ADDENDUM NO. 2

**FOR THE CONSTRUCTION OF THE
KIRK COMMUNITY AND SENIOR CENTER**

**ADDENDUM NO. 2
FOR THE CONSTRUCTION OF THE
Kirk Community and Senior Center**

SHEET
1/AD-2

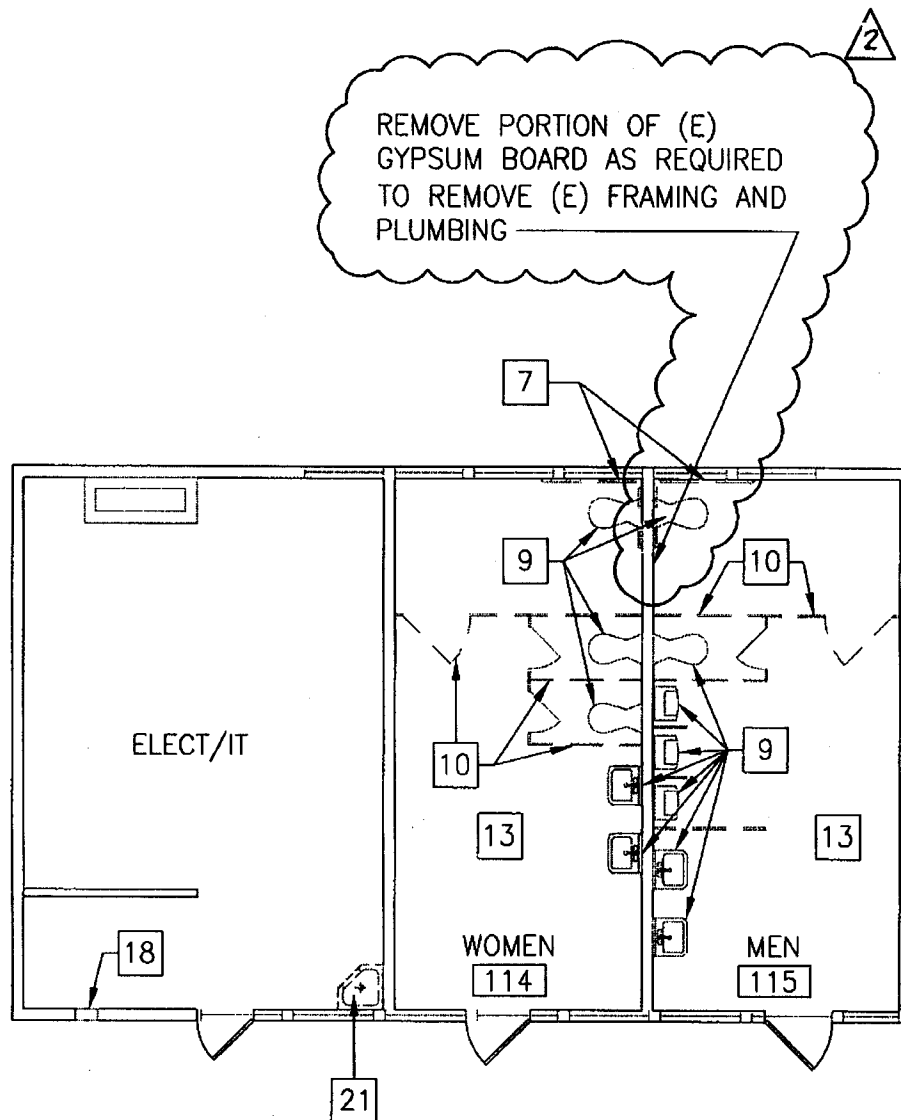
3. A2.0: **Add** note to detail 3 for the removal of gypsum board at plumbing wall of Building D. (See attached drawing 1/AD-2)
4. A2.0: **Add** note to detail 4 for the removal of acoustical ceiling where the new kitchen area is located. (See attached drawing 2/AD-2)

SHEET
3/AD-2

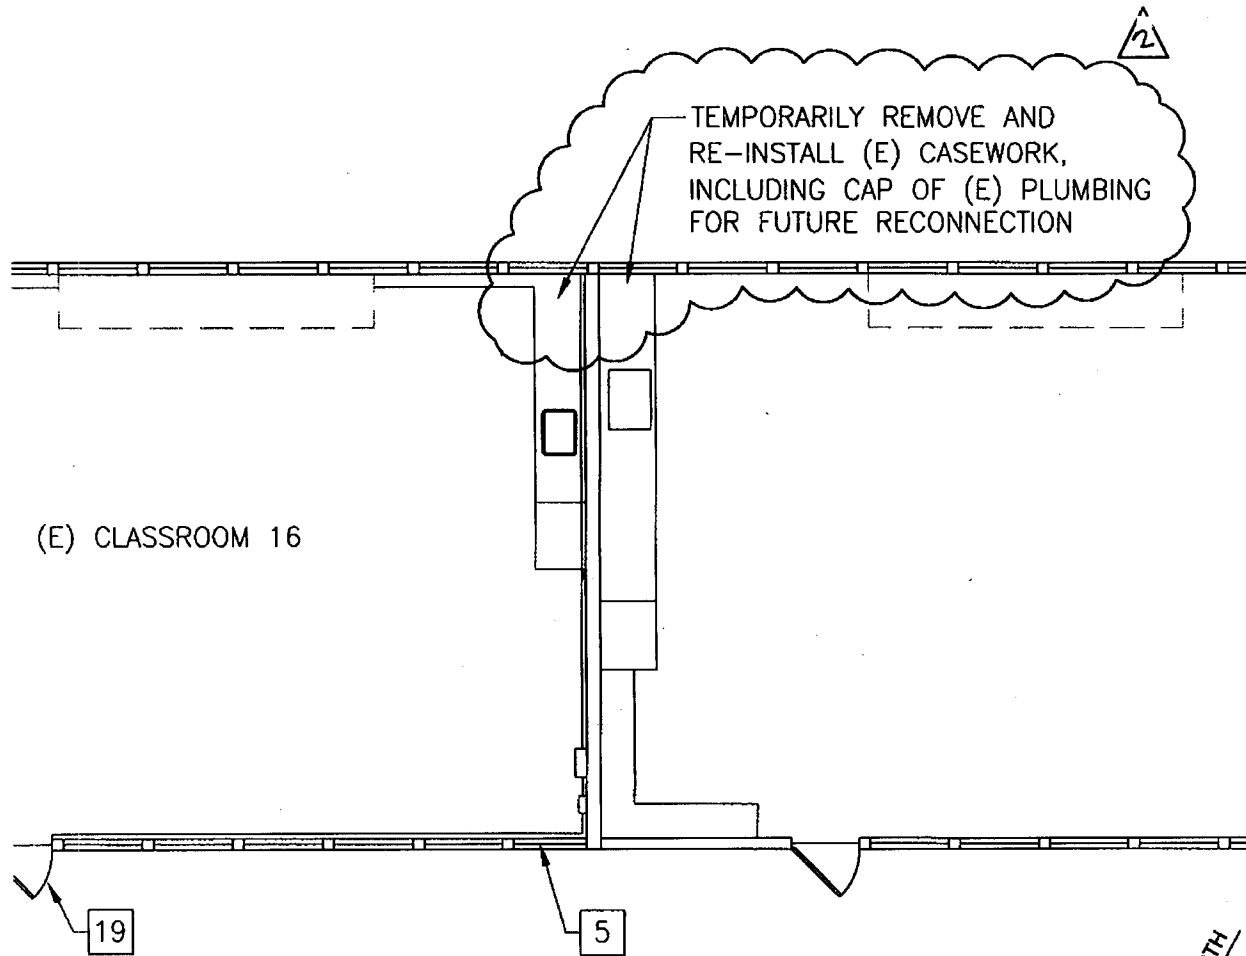
5. A2.0: **Add** note to detail 4 for the removal of the casework and cap of the existing plumbing temporarily at the fire barrier between Classroom 15 & 16. (See attached drawing 3/AD-2)

SHEET
4/AD-2

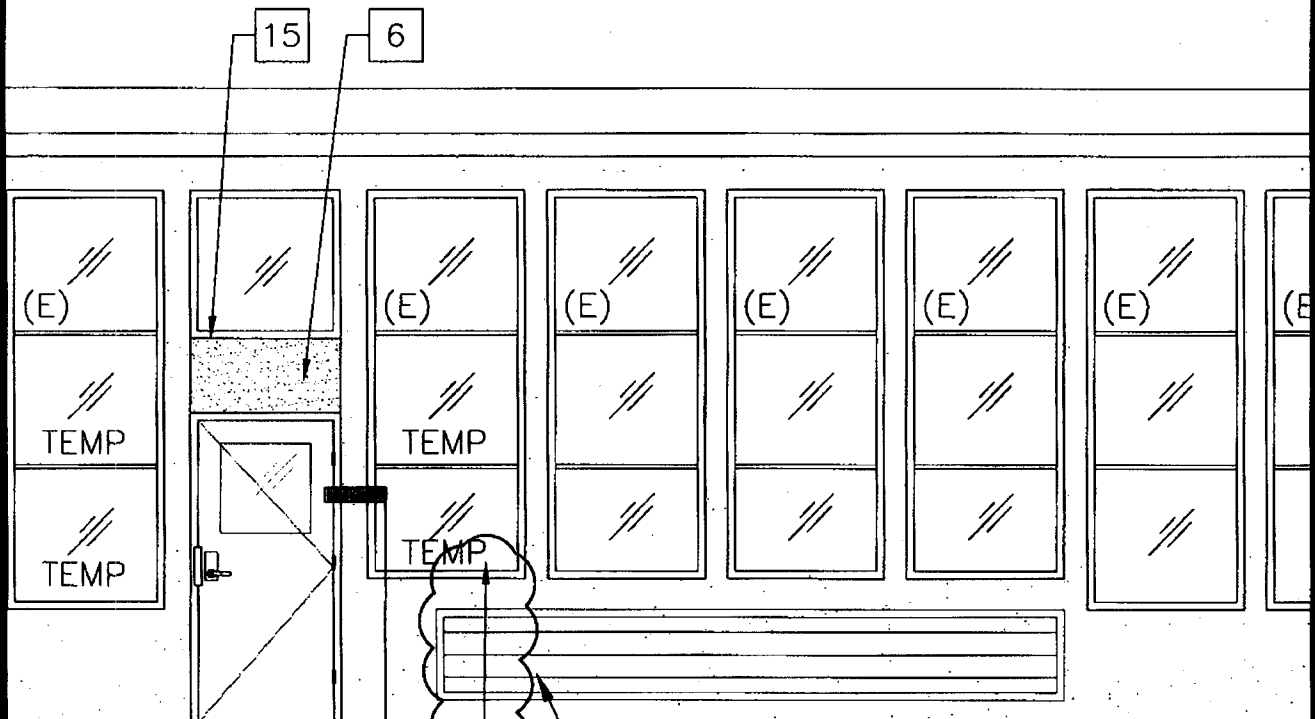
6. A3.2: **Add** note to detail 2 for the tapered section of the exposed rafter joist of the roof. (See attached drawing 4/AD-2)
7. A3.1: **Add** note to remove and replace existing glazing with tempered glazing for windows adjacent to new doors. (See attached drawing 5/AD-2)

2 TRAP PRIMING CONN DETAIL

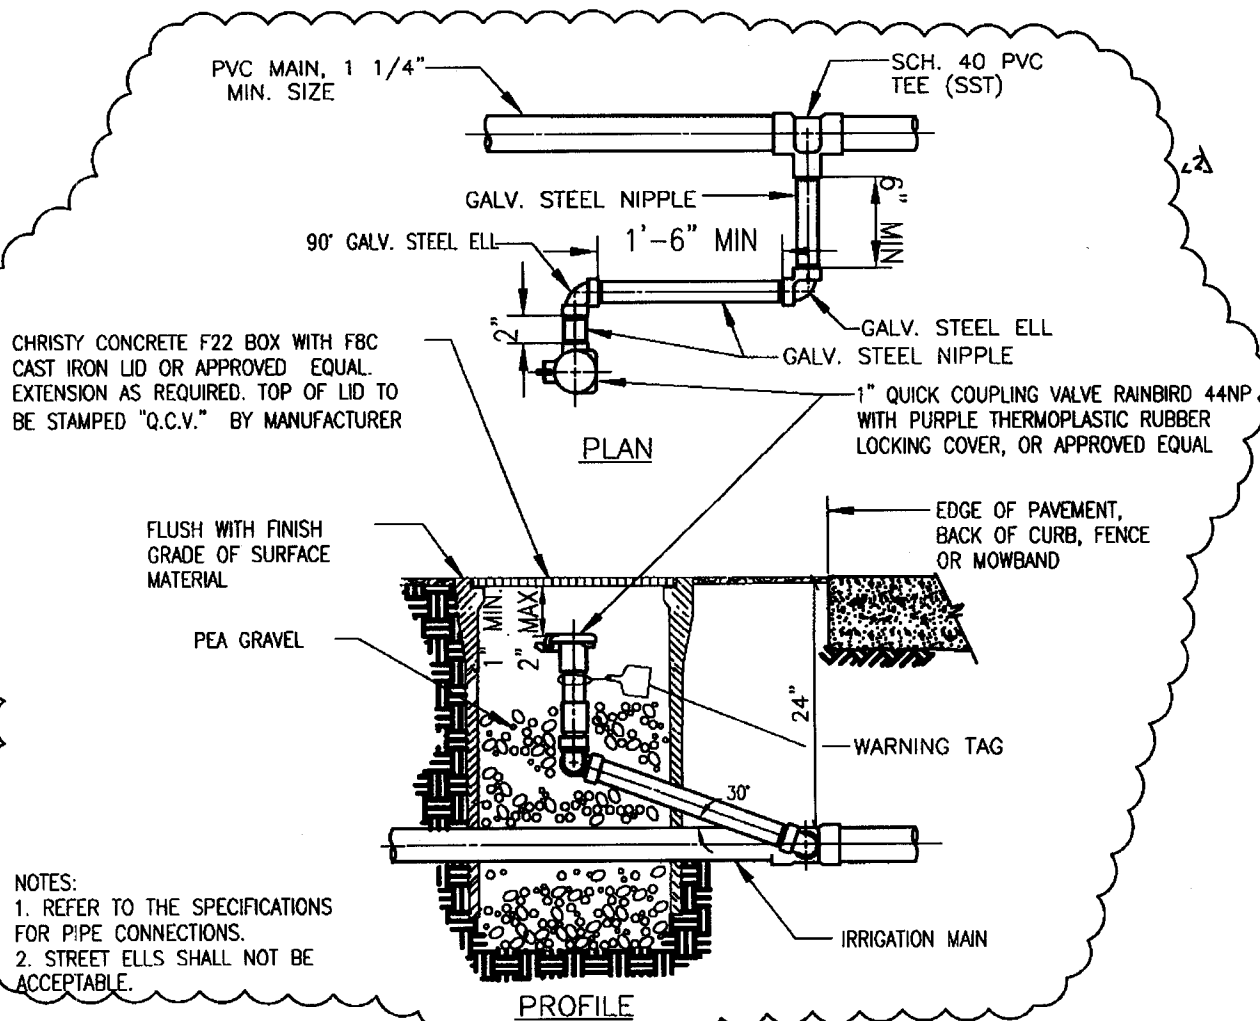
10. P0.0: **Replace** detail 2 in its entirety. (See attached drawing 6/AD-2)
11. E0.0: **Revise** the Signal and Communication Legend description for the Telephone/Data Outlet to indicate "4 cable drops at each outlet U.O.N."

SHEET
7/AD-2

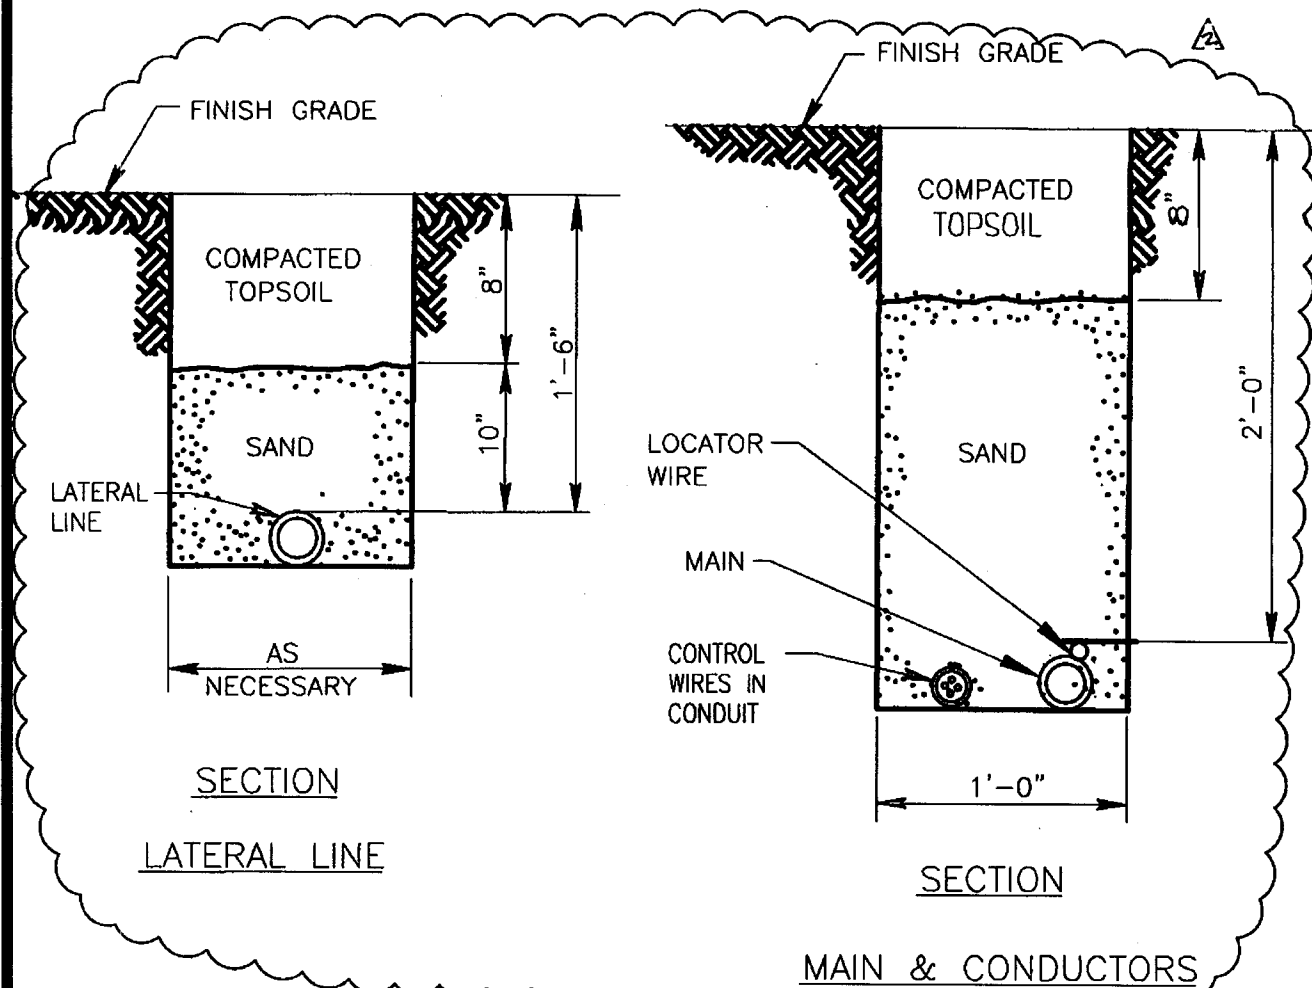
16. L-5: **Replace** detail 7 in its entirety. (See attached drawing 7/AD-2)
17. L-5: **Replace** detail 9 in its entirety. (See attached drawing 8/AD-2)

KITCHELL	ADDENDUM #2	PROJECT # 3536A3
2750 Gateway Oaks Drive Suite 300 Sacramento, CA 95833 Fax (916) 648-6534 Phone (916) 648-9700	KIRK COMMUNITY AND SENIOR CENTER 1601 FOXWORTHY AVE SAN JOSE, CA	DATE: 11/17/08 SHEET 9/AD-2

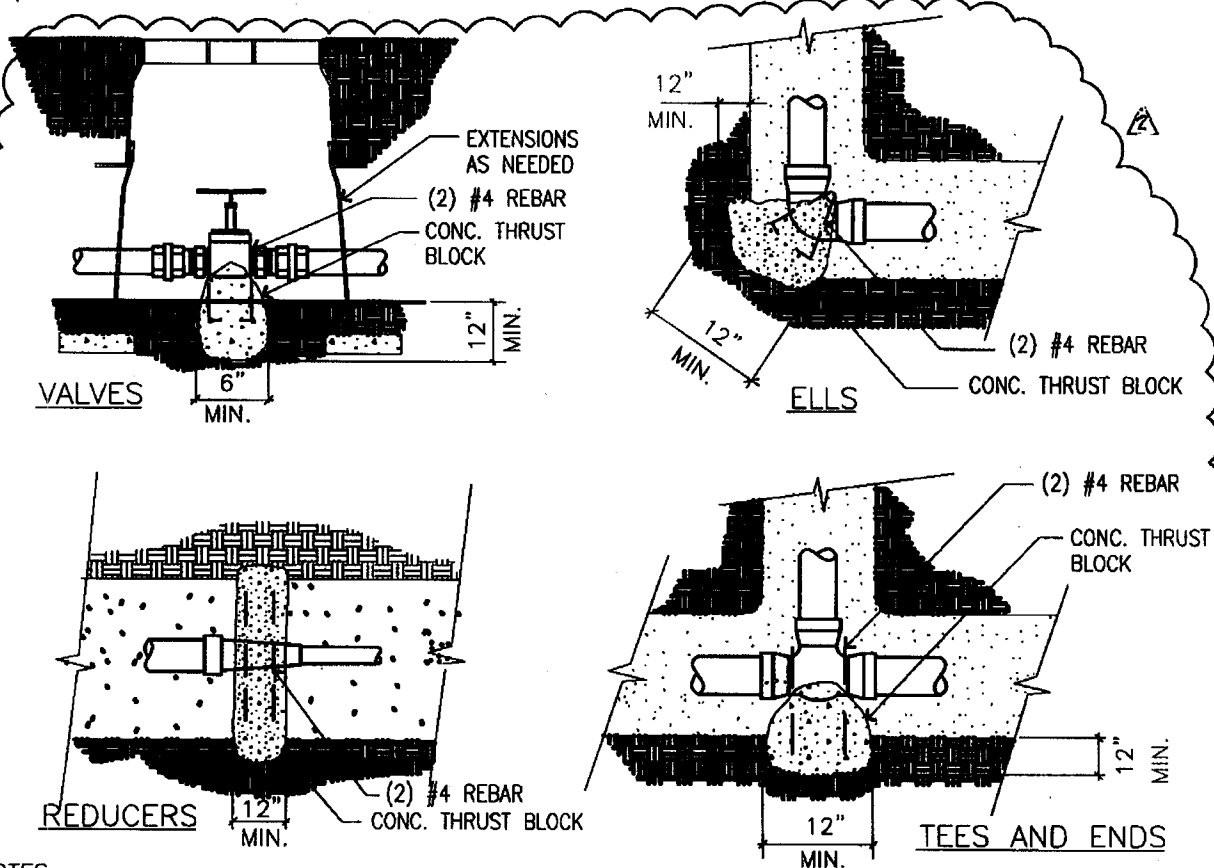
18. L-5: **Replace** detail 10 in its entirety. (See attached drawing 9/AD-2)
19. L-5: **Replace** detail 13 in its entirety. (See attached drawing 10/AD-2)

SHEET
11/AD-2

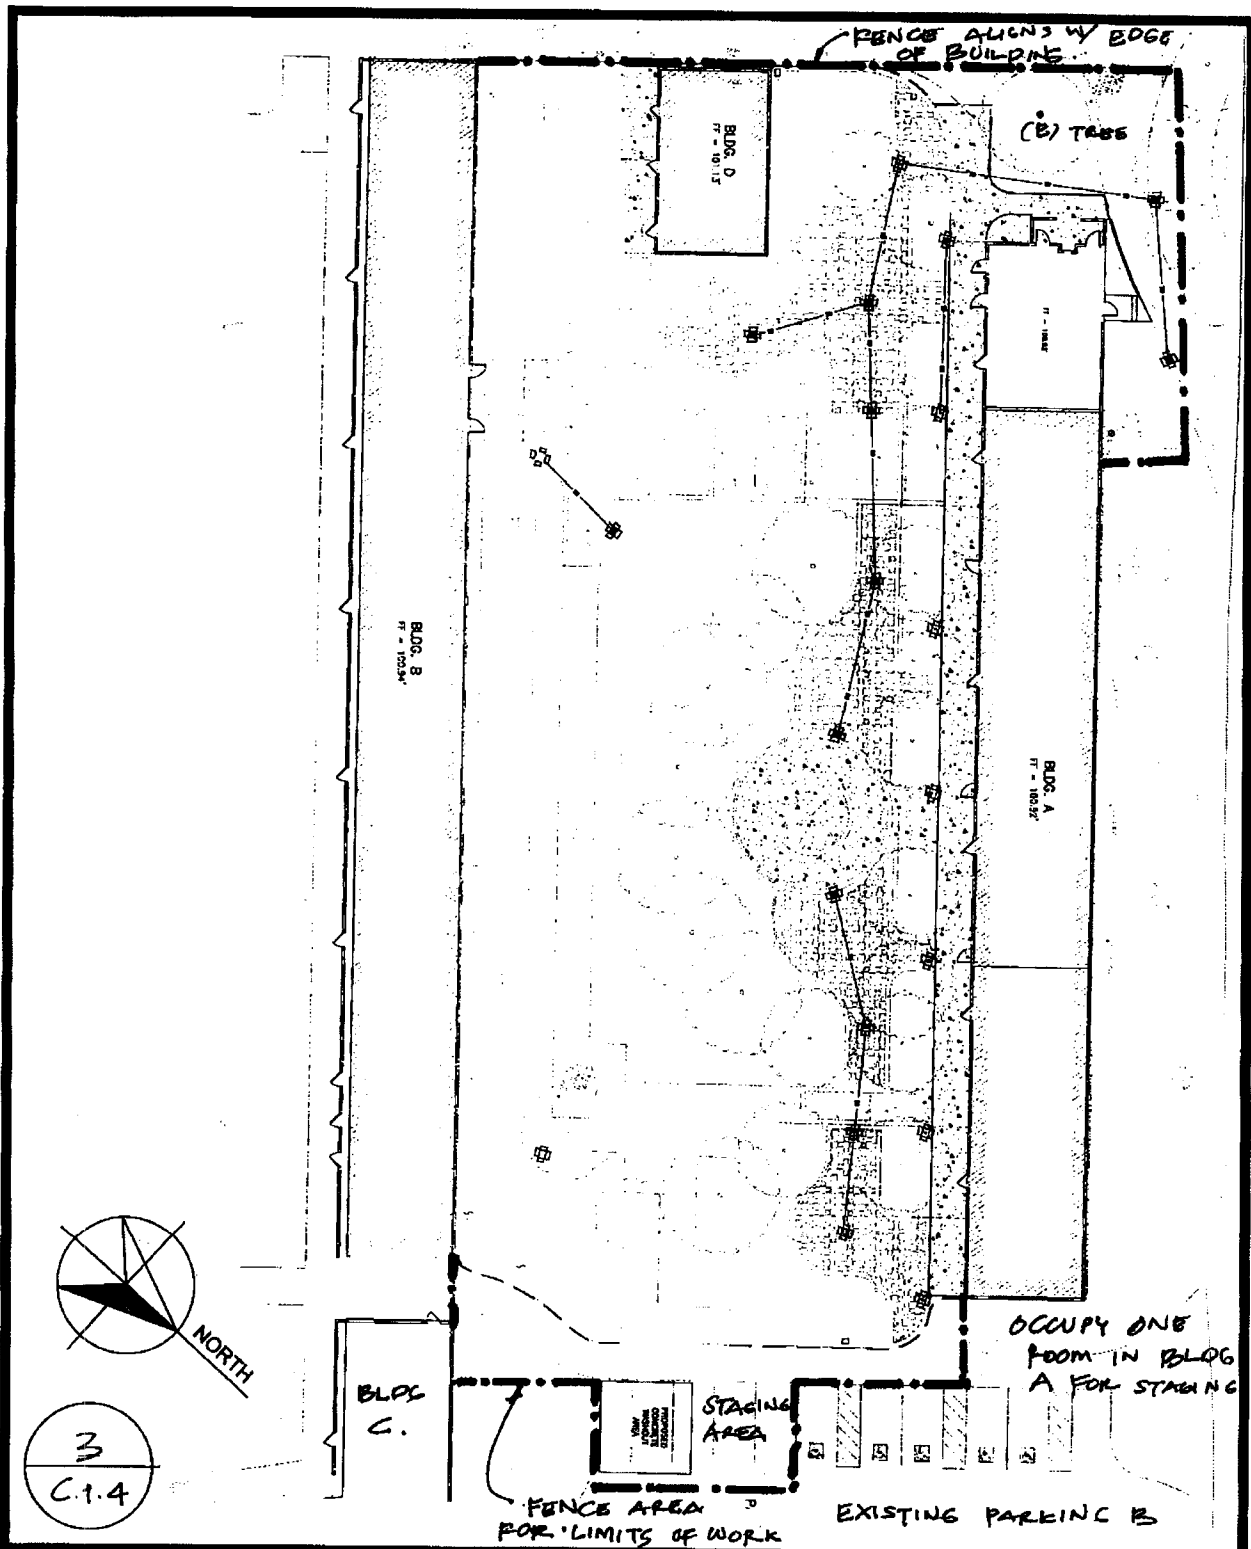
20. L-5: **Replace** detail 14 in its entirety. (See attached drawing 11/AD-2)
21. C-1.4: **Add** detail 3 to the sheet in its entirety for the fence limit of work. (See attached drawing 12/AD-2)
